SUBJECT: Entergy Nuclear Operations, Inc.  
Pilgrim Nuclear Power Station  
Docket No. 50-293  
License No. DPR-35

Proposed Change to Applicability of Pilgrim's Pressure-Temperature  
Curves as Described in Technical Specification Figures 3.6.1, 3.6.2, and  
3.6.3, Revision 1

LETTER NUMBER: 2.07.006

## **Evaluation of Proposed Technical Specifications Amendment**

**PILGRIM REACTOR VESSEL PRESSURE-TEMPERATURE LIMITS**  
**HYDROSTATIC AND LEAK TESTS**

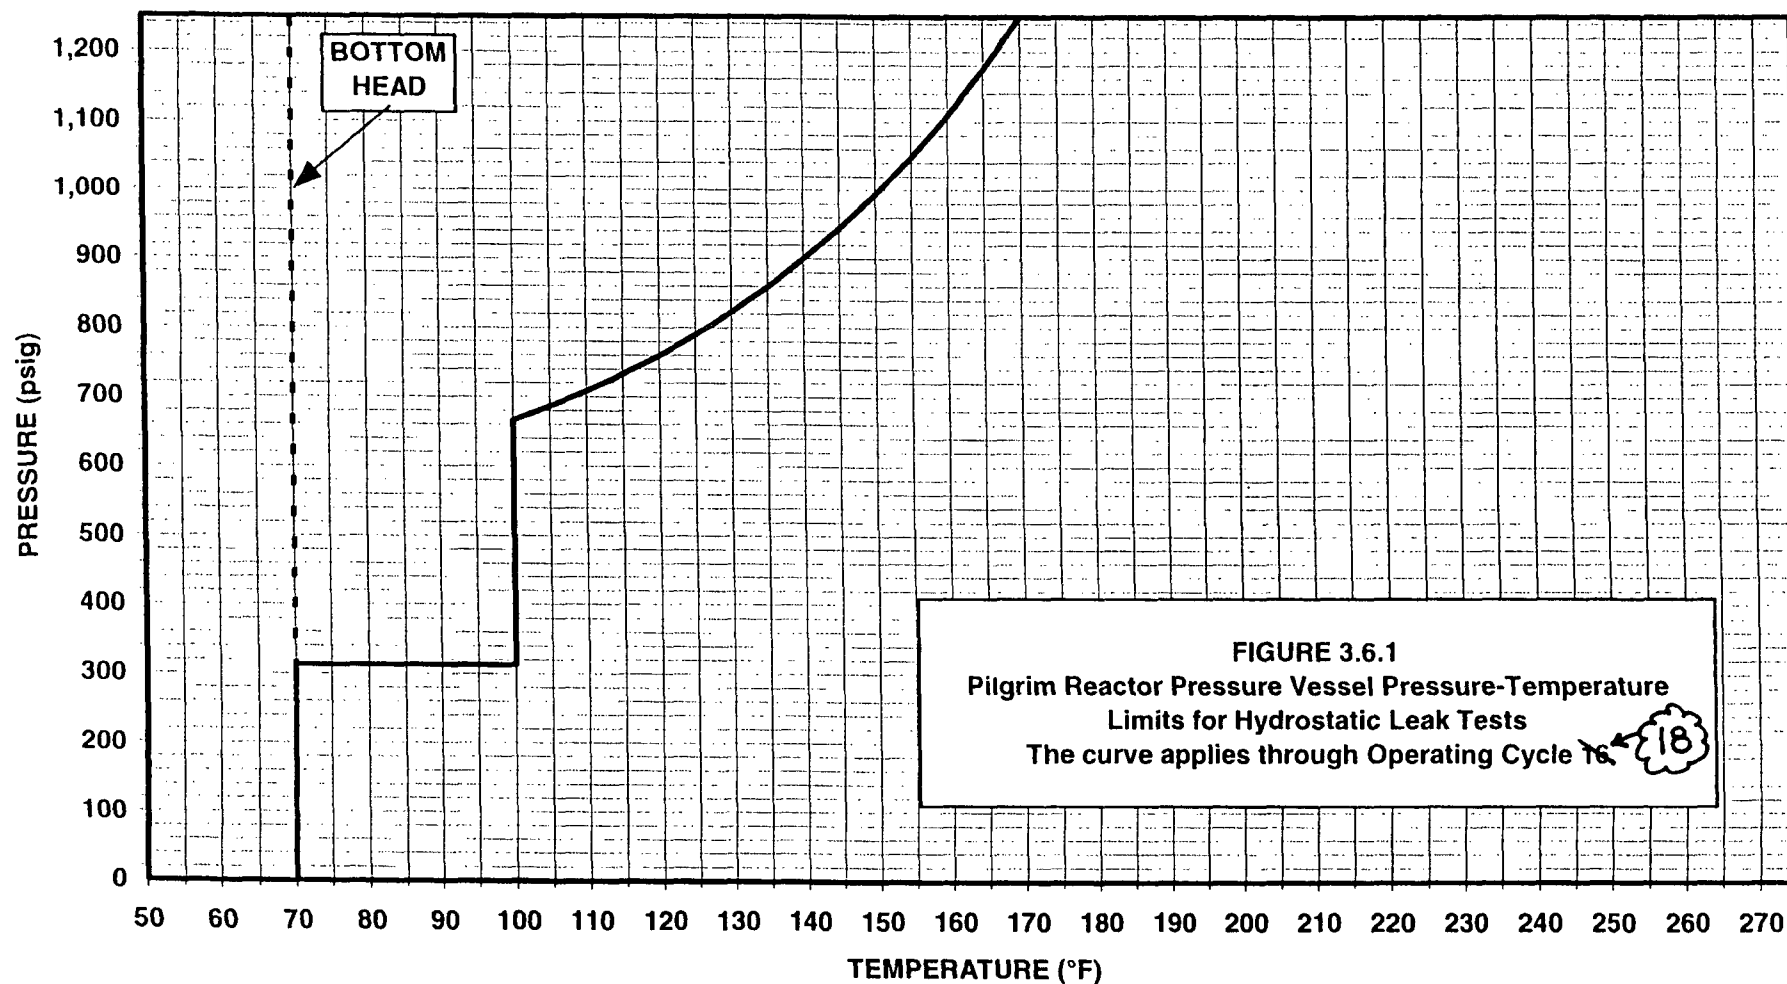
Currently, the title blocks for Figures 3.6.1, 3.6.2, and 3.6.3 contain, in part, the words:

“The curve applies through Operating Cycle 16.”

The proposed amendment changes the words to:

“The curve applies through Operating Cycle 18.”
